Planning Board – Monday, September 24, 2018, 6:30PM
City Hall Council Chambers – 3 Washington Street, 2nd floor
AGENDA

SPR-11-16 MODIFICATION #6 – 81, 95 & 100 WYMAN ROAD – HILLSIDE VILLAGE CONTINUING CARE RETIREMENT COMMUNITY

SPR-930 MODIFICATION 4 - SITE PLAN REVIEW – 11 PRODUCTION AVE – ADDITION TO SUBARU OF KEENE

Sheet No.1 of 2 - Boundary Plan

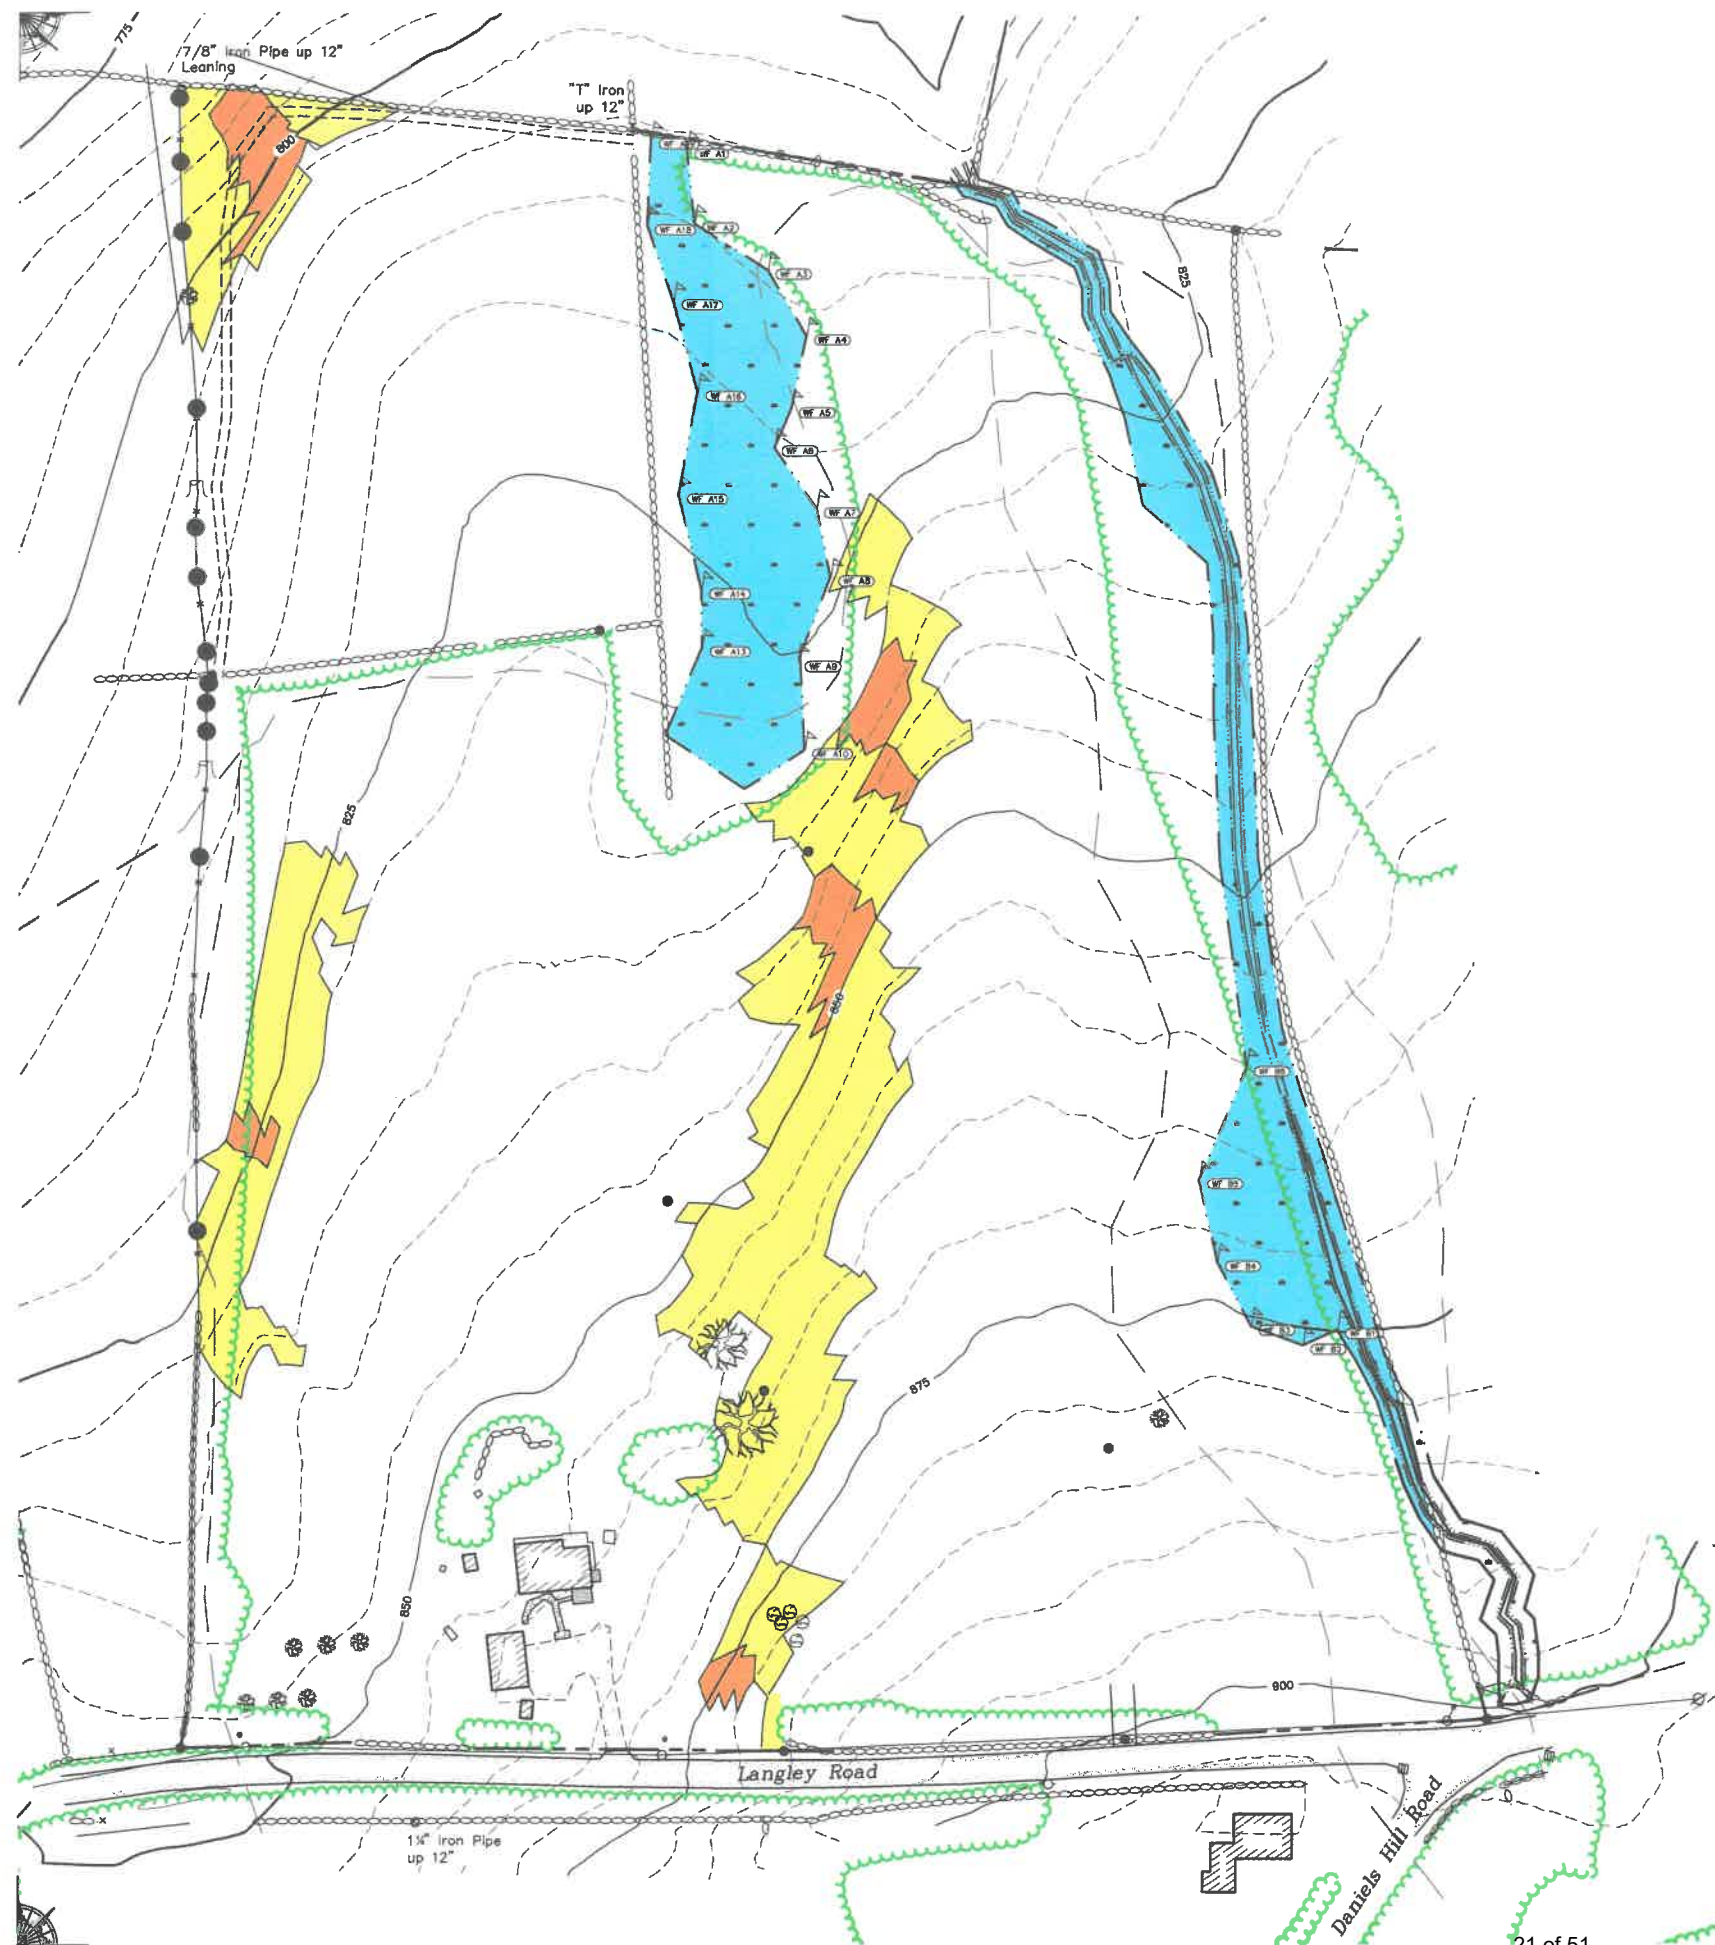
“1. The common driveway should be recorded as a deeded easement.

1. Drainage: Although no new development is proposed at this time, the Applicant has included on the submitted Subdivision Plan the location and dimensions of a 100' long x 40' wide common driveway easement area, with a 15' wide curb cut on Langley Road at the center of this area, for proposed Lots 2 and 3. It will be the responsibility of the owner and any future owners to adhere to all applicable standards related to the installation and construction of driveway and parking areas at the time of development.

The proposed common driveway is located approximately 180’ from the intersection of Daniels Hill Road and Langley Road. There appears to be safe sight distance to the east from the proposed driveway location. To the west of the proposed driveway, there is a hill that drops in elevation towards the existing house on the site. This grade change may impact sight lines looking west; however, the speed and traffic volume on Langley Road, which dead ends to the west, are low and there is some sight distance between the crest of the hill and the proposed driveway entrance.

SHEET 2

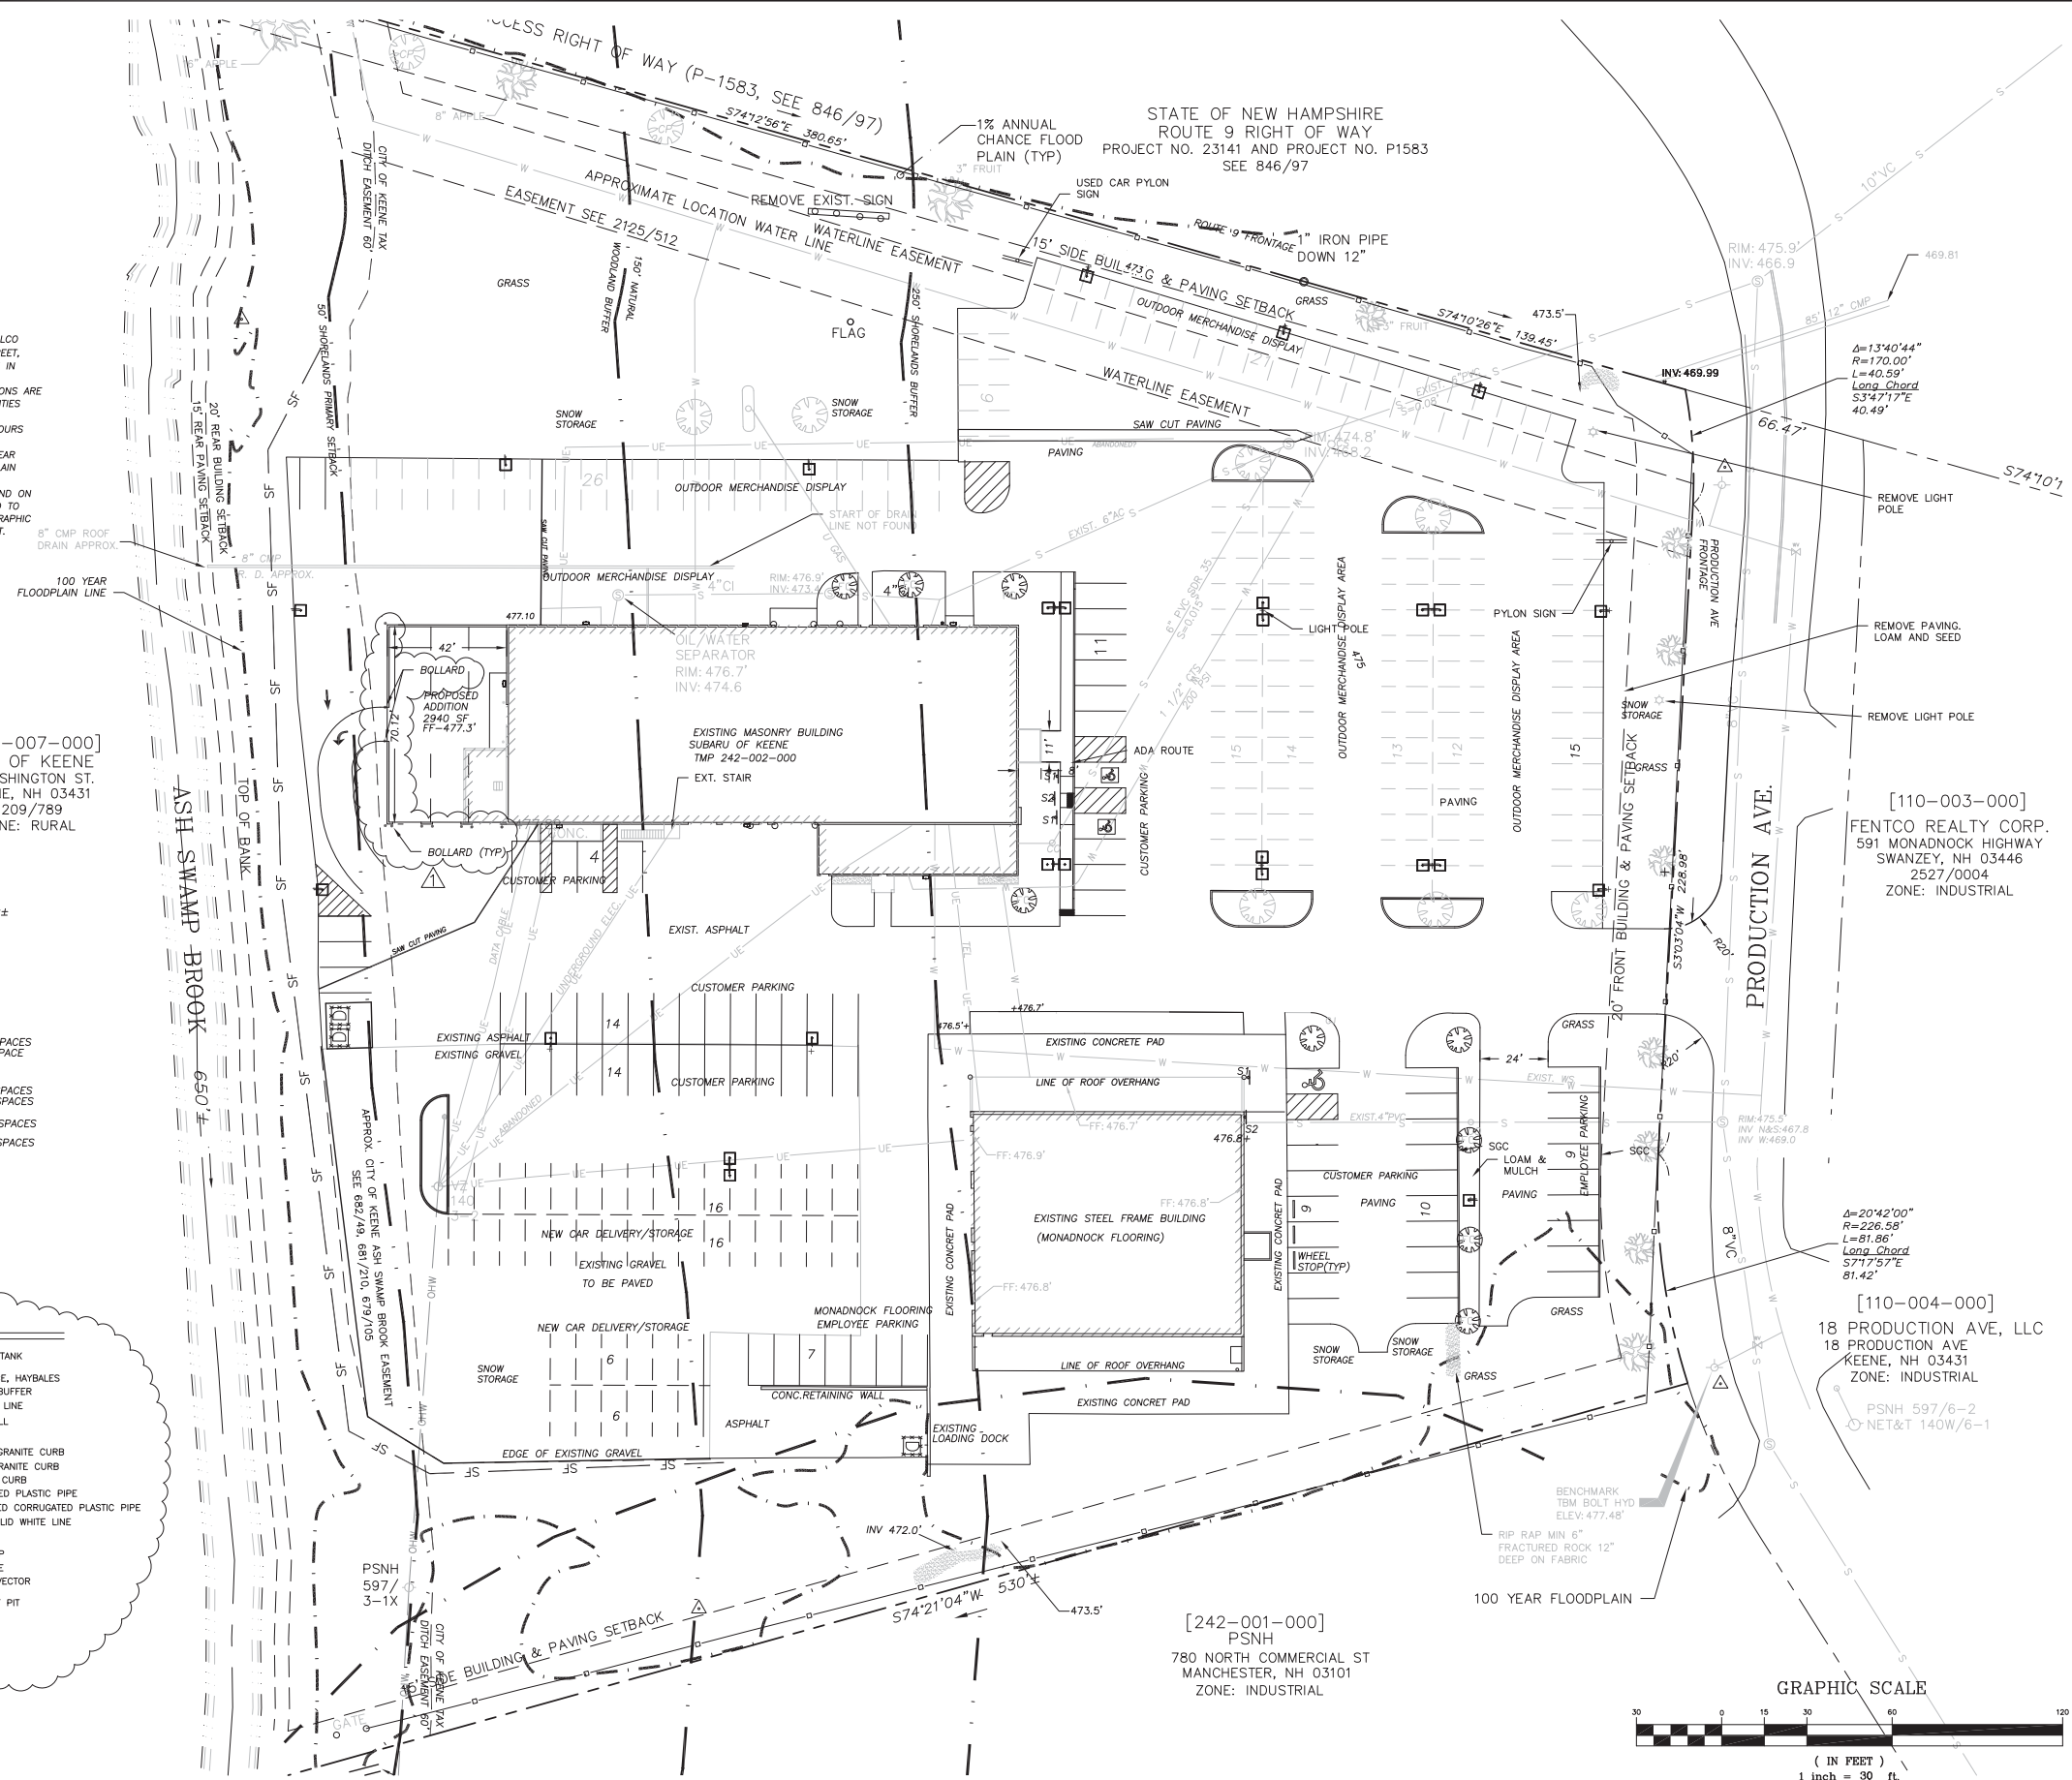
- Please include elevations stamped by an architect registered in NH per Planning Board Site Plan Regulation Section IV.D.2.a.1.
- Sheet 2 of the plan set labels the proposed addition as 4,350 sf. However, the narrative and elevations confirm that it is 2,940 sf. Please, revise the plan sheet to include the correct square footage.

SHEET 3

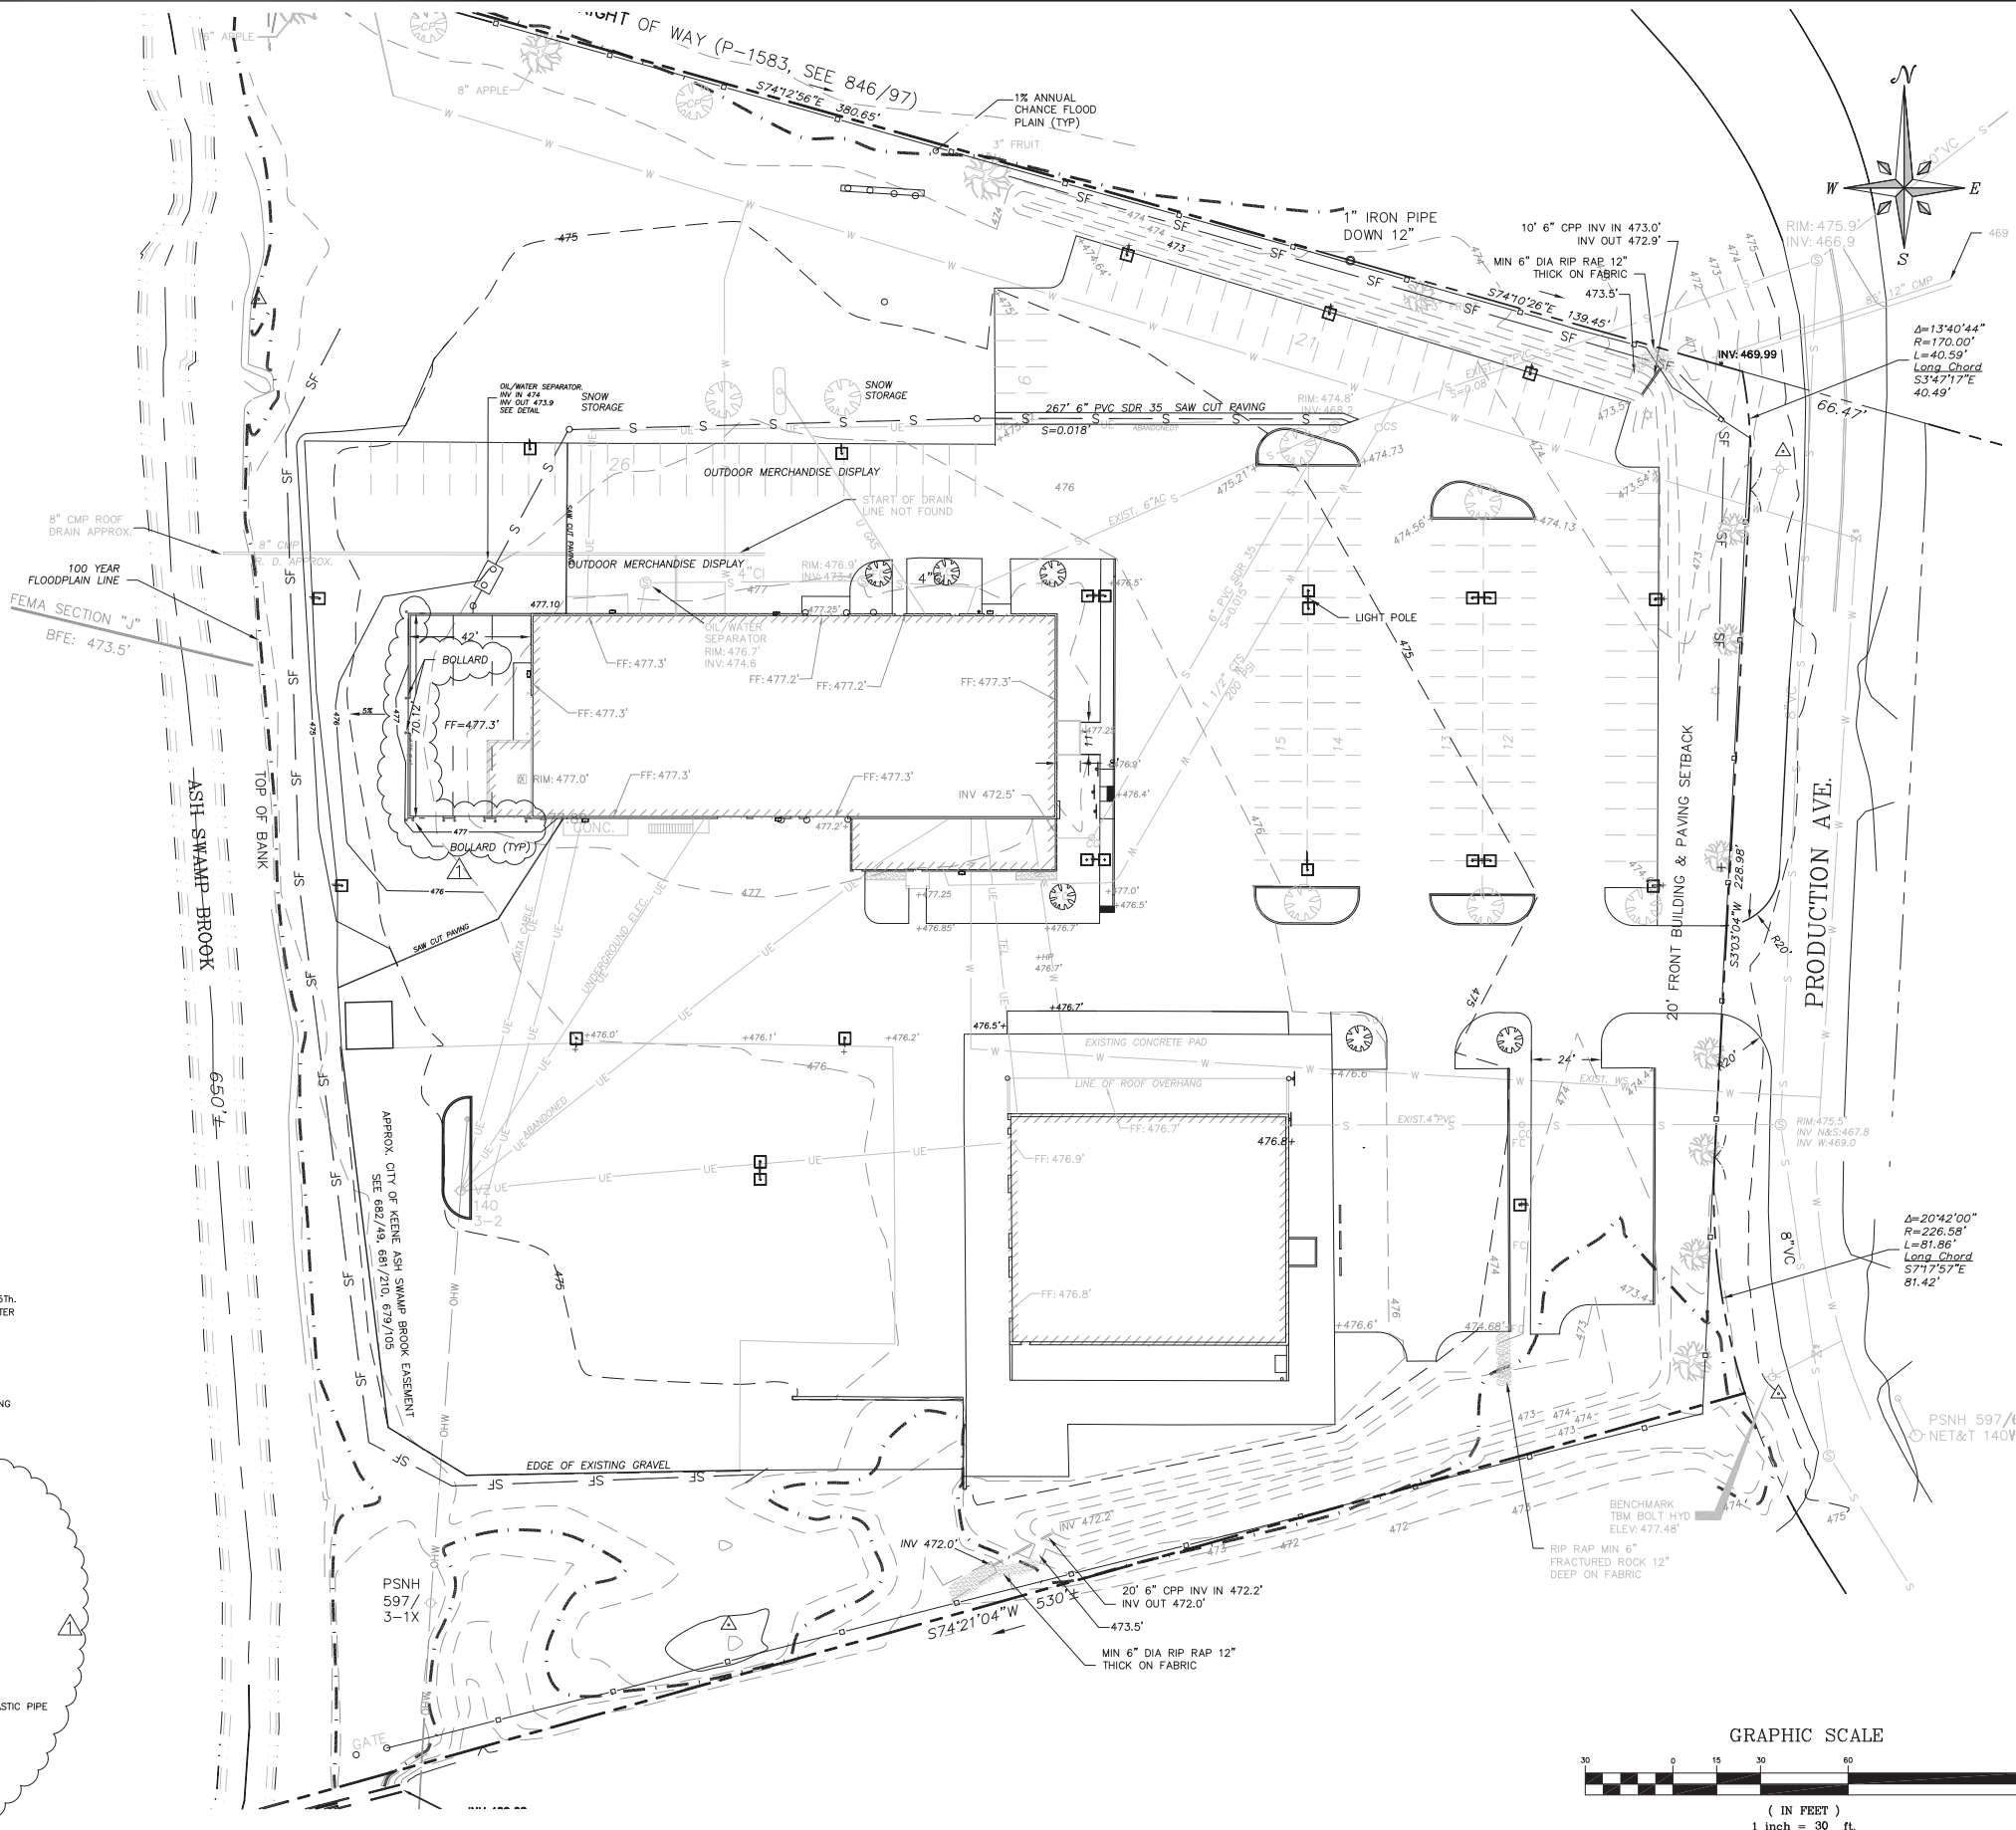
- Will a permit be required from NH DES for work in the Shoreland Protection Zone?
- On Sheet 3, please extend the silt fence to wrap around the southwest edge of the parking area to provide added protection against sedimentation of Ash Swamp Brook.
